IEEE P802.15
Wireless Personal Area Networks

Project	IEEE P802.15 Working Group for Wireless Personal Area Networks (WPANs)	
Title	MSCs Incorporating New FC SL/DME/MLME Functional Division and Imm-ACK Removal	
Date Submitted	[24 May, 2004]	
Source	[John Sarallo] [Apparent Technologies] [150 Lucius Gordon Drive, West Henrietta, NY 14586]	Voice: [585-727-2014] Fax: [585-214-2461] E-mail: [sarallo@apparent.com]
Re:	[]	
Abstract	[This document contains a list or proposed changes to IEEE Std 802.15.3.]	
Purpose	[The purpose of this document is to propose changes to IEEE Std 802.15.3 to improve compatibility, performance and clarity in the standard.]	
Notice	This document has been prepared to assist the IEEE P802.15. It is offered as a basis for discussion and is not binding on the contributing individual(s) or organization(s). The material in this document is subject to change in form and content after further study. The contributor(s) reserve(s) the right to add, amend or withdraw material contained herein.

This document presents new clause 8 MSCs resulting from Imm-ACKs no longer being used as confirmation commands as presented in 04/202r0 and with the following functional division

Figure 142 - MSC showing a DEV joining an existing SPS set

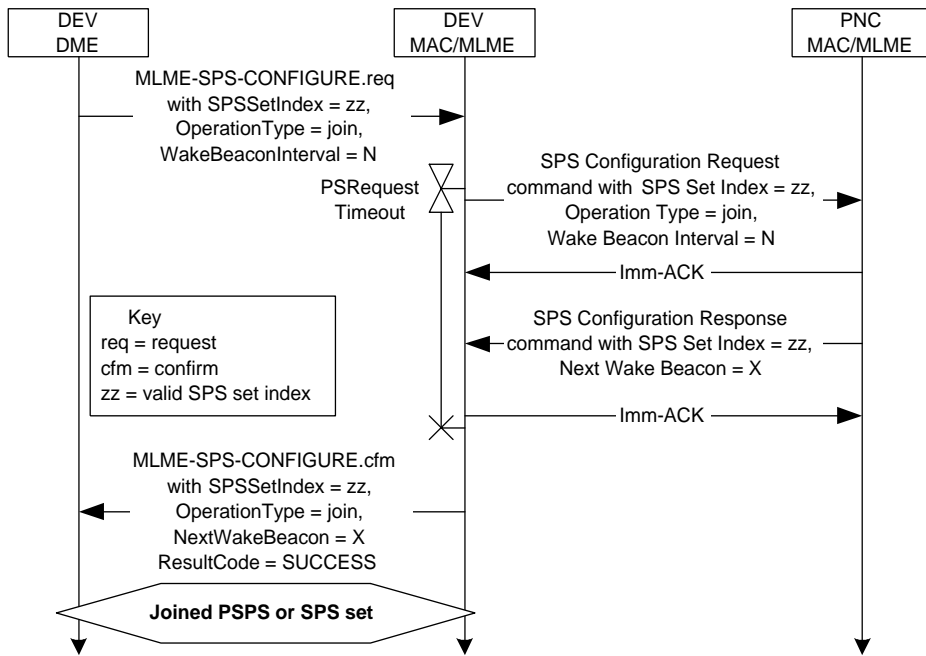
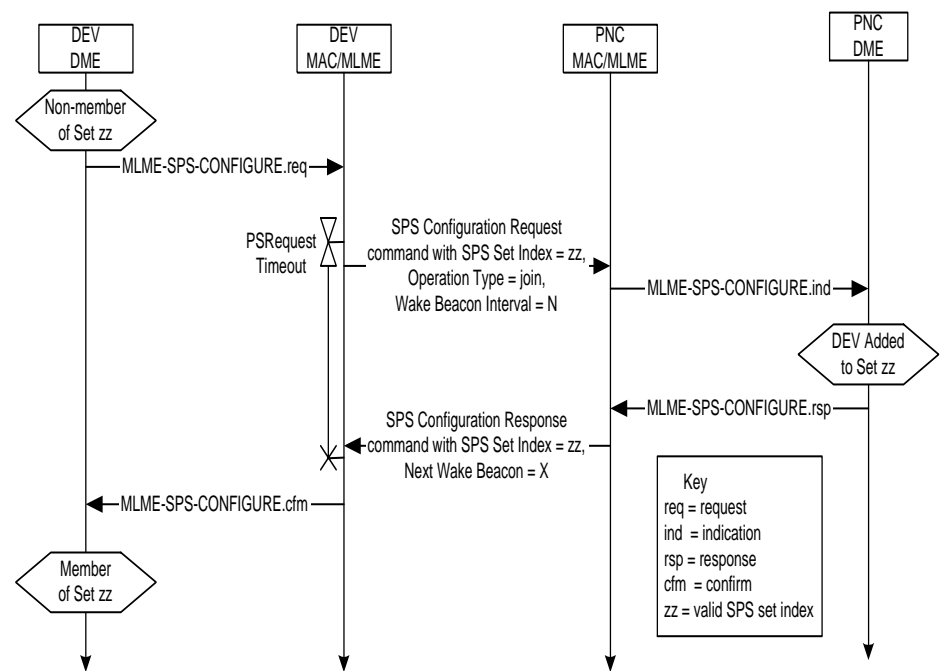
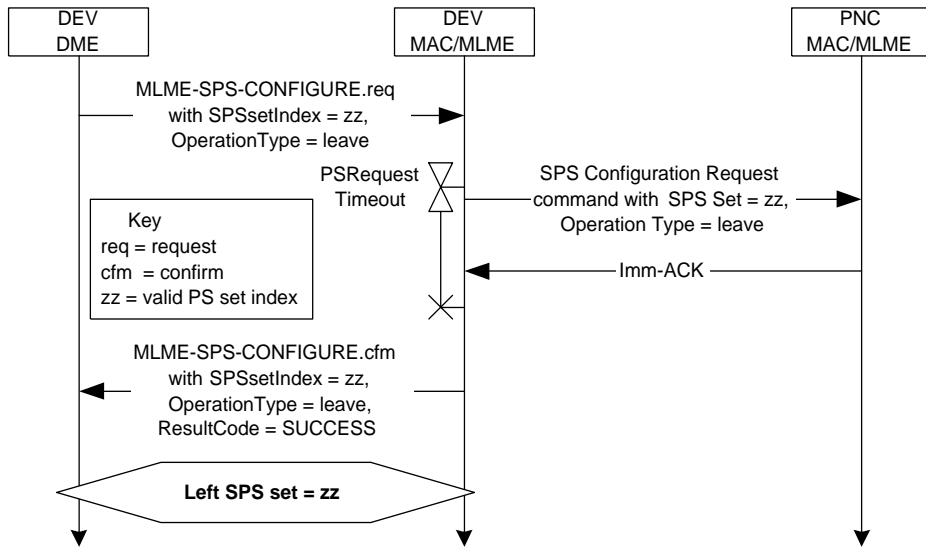
- PME is responsible for maintaining power set information, therefore, MLME-SPS-CONFIGURE indication and response primitives are needed.

Figure 143 - MSC showing a DEV leaving an SPS set

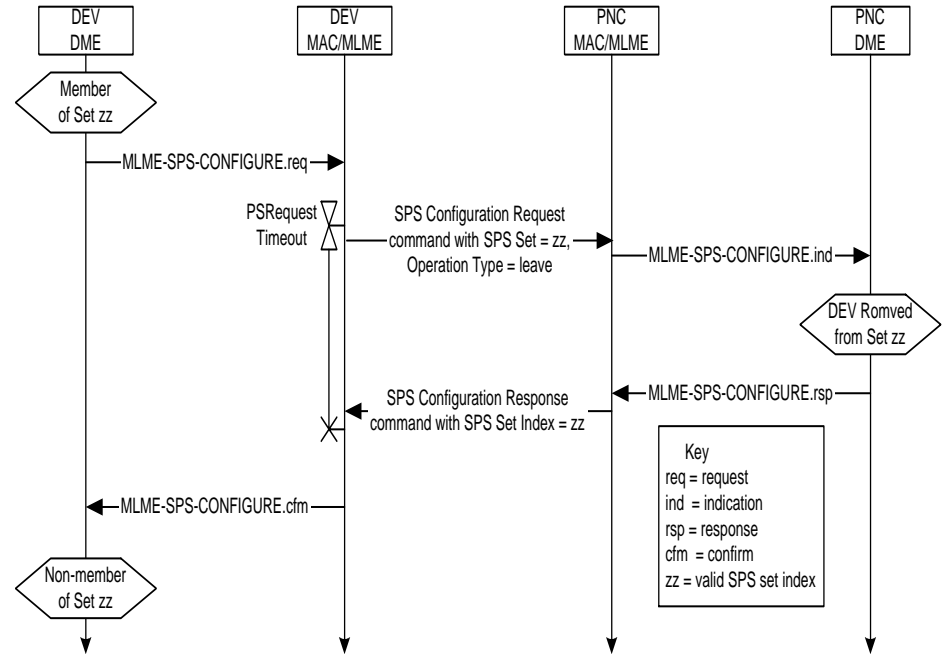
- PME is responsible for maintaing power set information, therefore, MLME-SPS-CONFIGURE indication and response primitives are needed.

Figure 144 - MSC showing DME initiated PM mode change from ACTIVE to an SPS mode

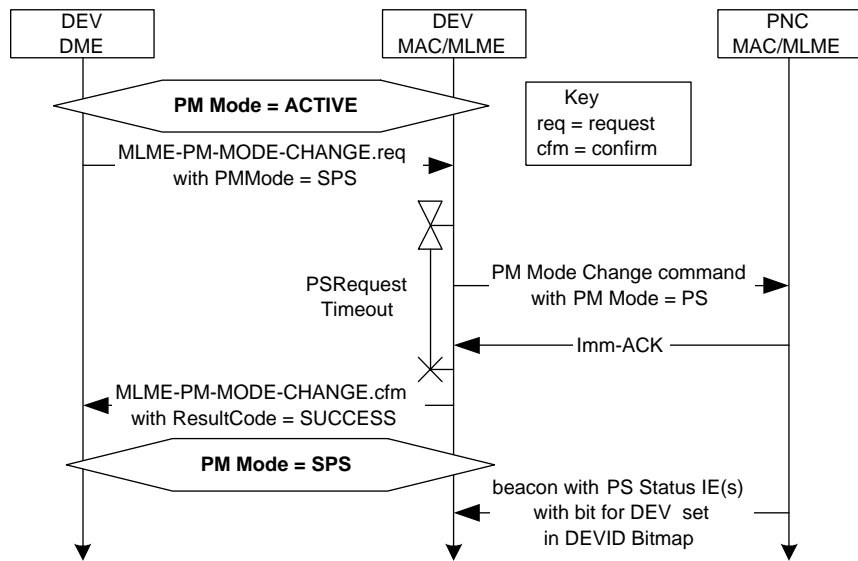
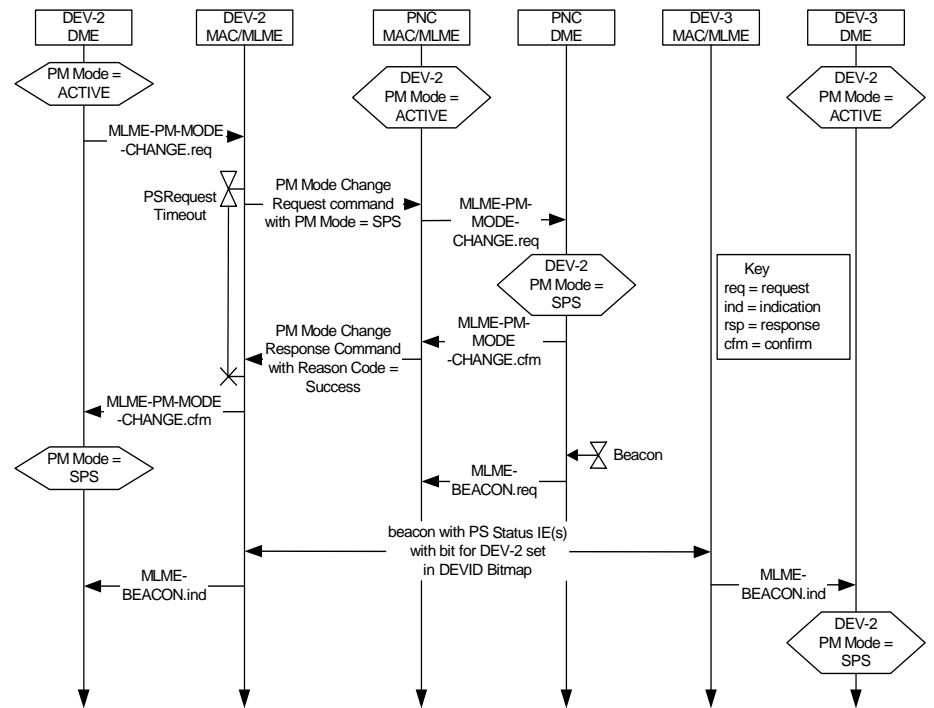
- PME is responsible for maintaing power save state information, therefore, MLME-PM-MODE-CHANGE indication and response primitives are needed.
- Other DEVs aware of mode change when they receive beacon.

Figure 145 - MSC showing DME initiated PM mode change from ACTIVE to APS

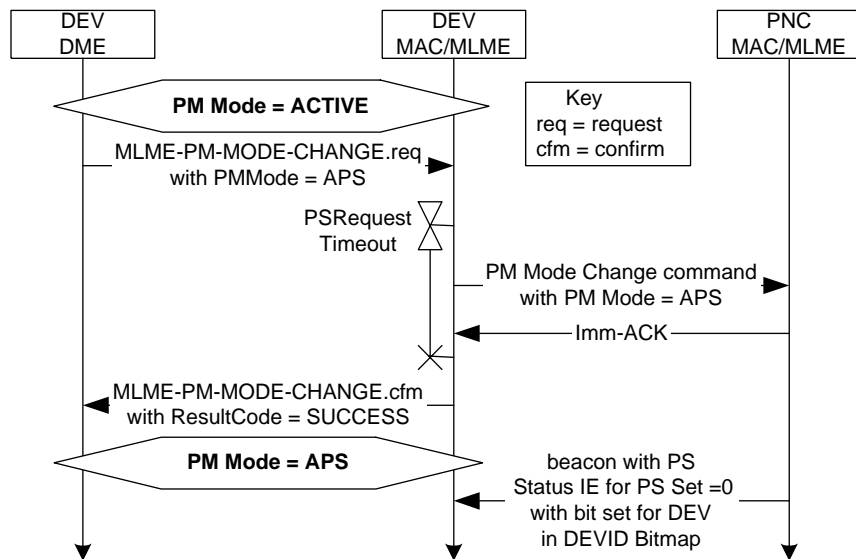
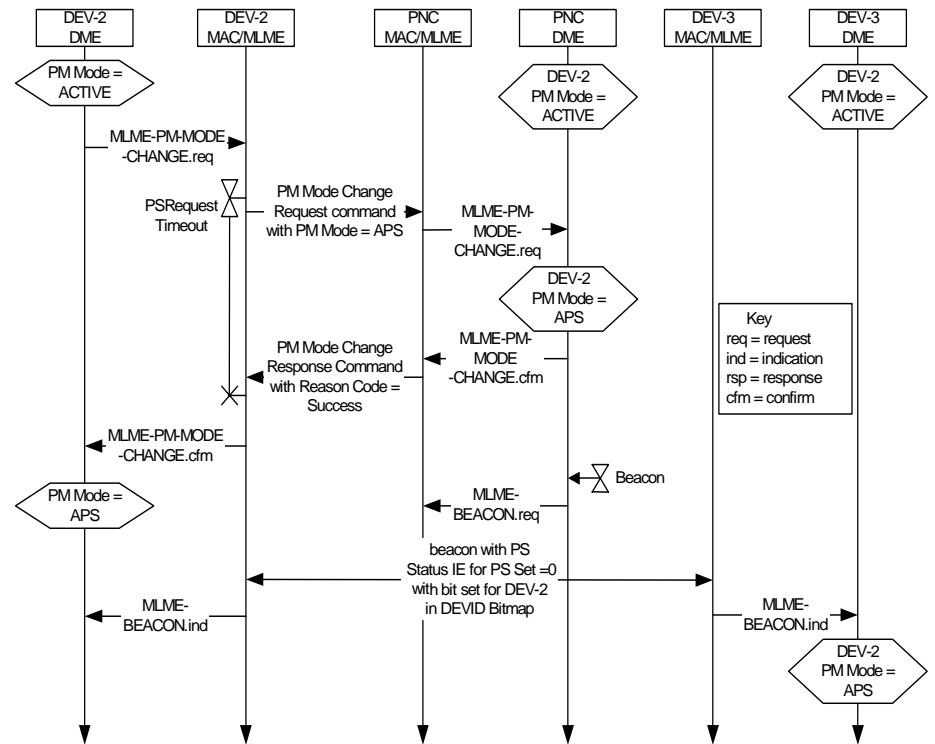
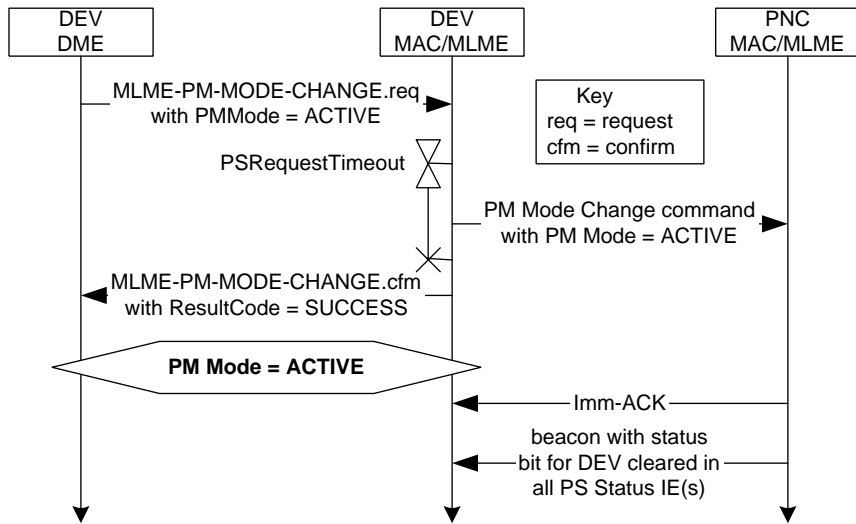
- PME is responsible for maintaining power save state information, therefore, MLME-PM-MODE-CHANGE indication and response primitives are needed.
- Other DEVs aware of mode change when they receive beacon.

Figure 146 - MSC showing DME initiated PM mode change from any PS mode to ACTIVE

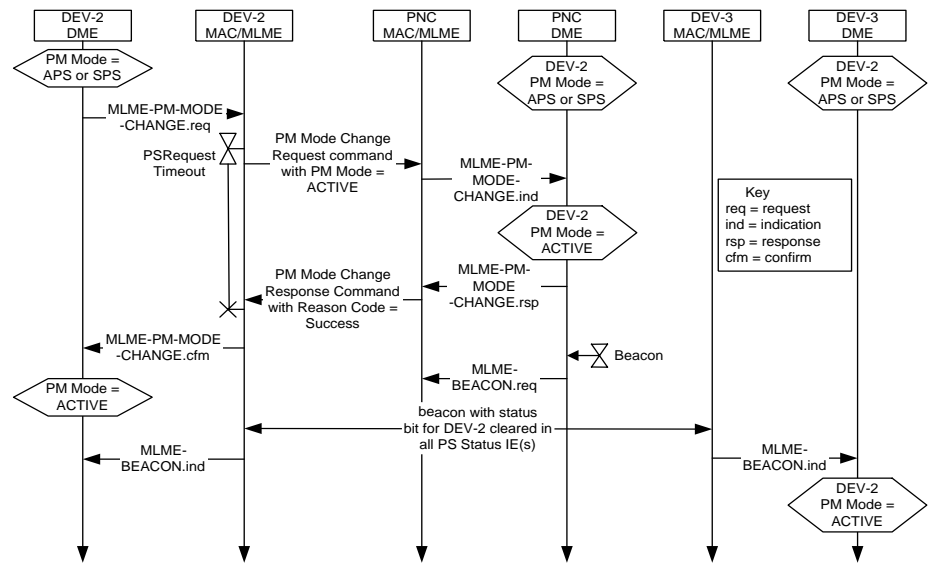
- PME is responsible for maintaining power save state information, therefore, MLME-PM-MODE-CHANGE indication and response primitives are needed.
- Other DEVs aware of mode change when they receive beacon.

Figure 148—Message sequence chart for DEV-DEV Security information request

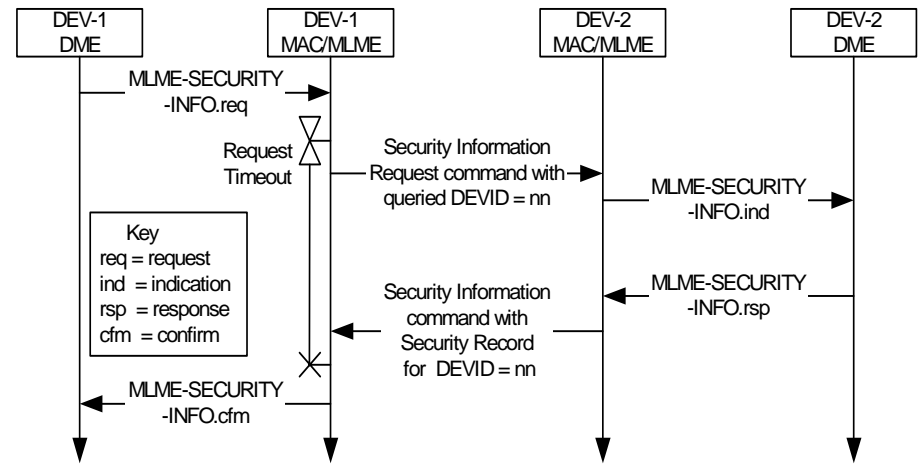
- Only change is Imm-ACKs removed.

Figure 150—Message sequence chart for sending security information with the Security Message command

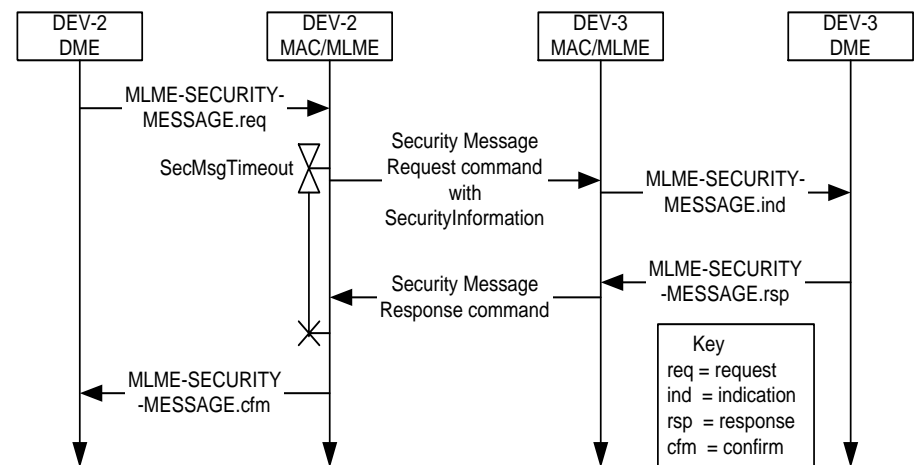
- MLME-SECURITY-MESSAGE response primitive and Security Message Response command added.

Figure 151—Message sequence chart for PNC-DEV key distribution

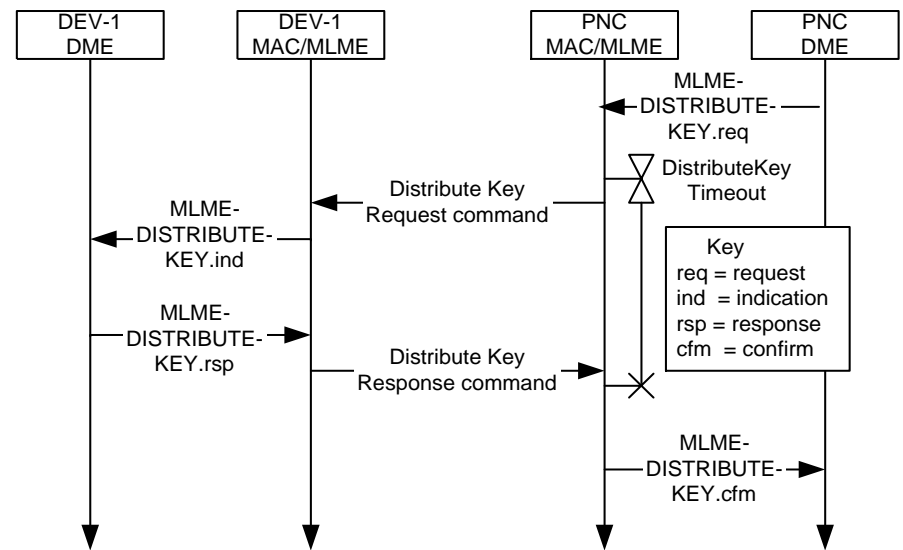
- MLME-DISTRIBUTE-KEY response and Distribute Key Response command added.

Figure 152—Message sequence chart for peer-to-peer key distribution

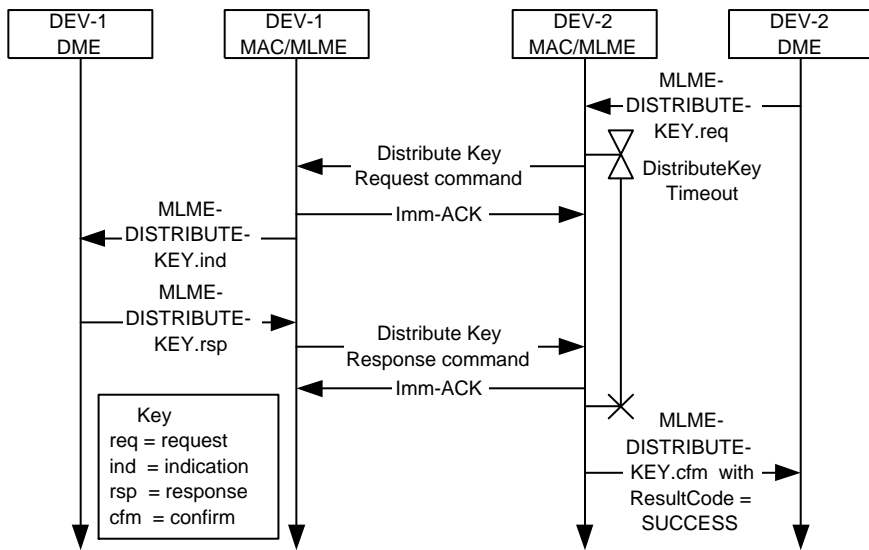
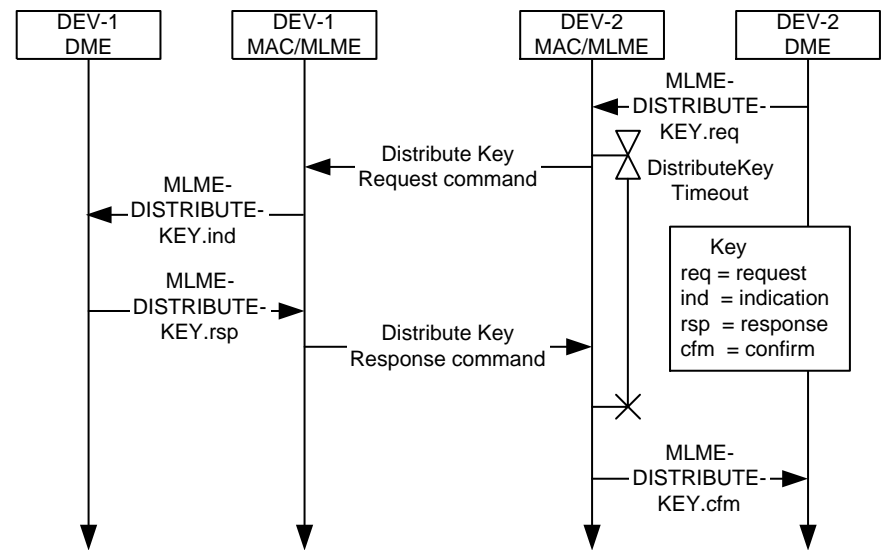
- Only change is Imm-ACKs removed.

Figure 153—Message sequence chart for DEV key request

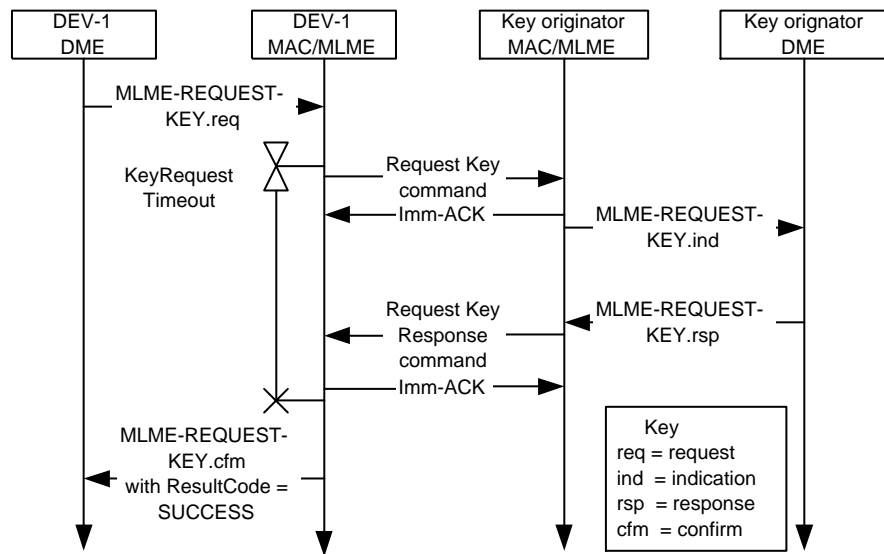
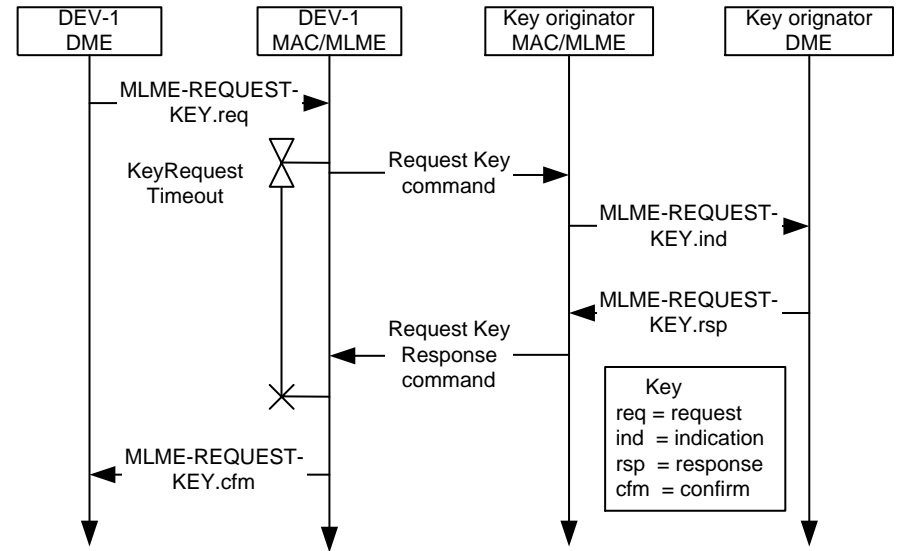
- Only change is Imm-ACKs removed.

Figure 101 - MSC for initiating a neighbor piconet

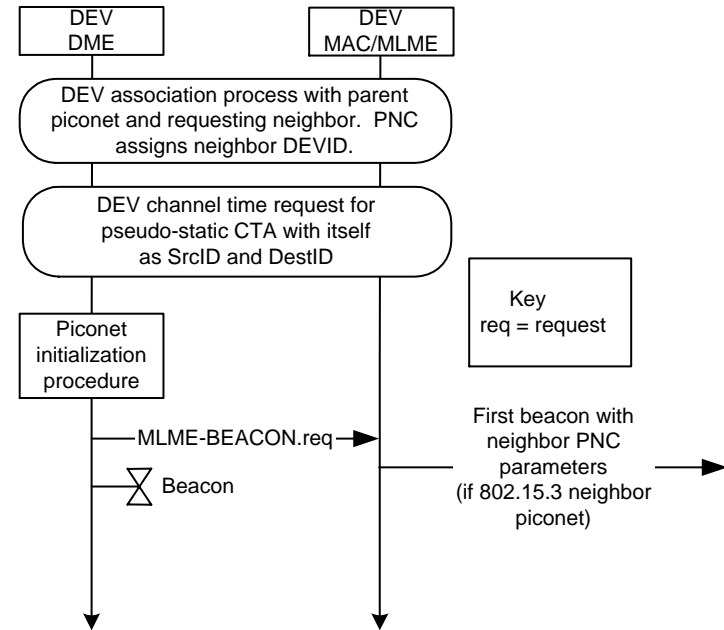
- The PME (PNC DME) maintains the information that is contained in a beacon so a MLME-START primitive is no longer needed because the PME can simply make a request to send a beacon when it is ready to start a piconet.
- When a piconet is started, a Beacon timer is required for transmitting beacons at the superframe interval.
